FIRE SAFETY INSPECTION REPORT

SF SWEATERS LTD

ACCORD
on Fire and Building Safety in Bangladesh

May 28, 2014

F-6 Egress

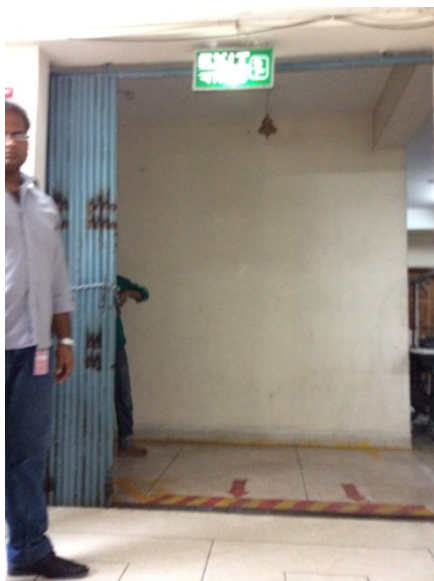
Sliding doors are provided at every exit stairs.

Replace all gates / sliding doors along the means of egress with side-hinged, swinging egress doors.

If locks are required for security reasons, utilize special door locking features complying with NFPA 101.
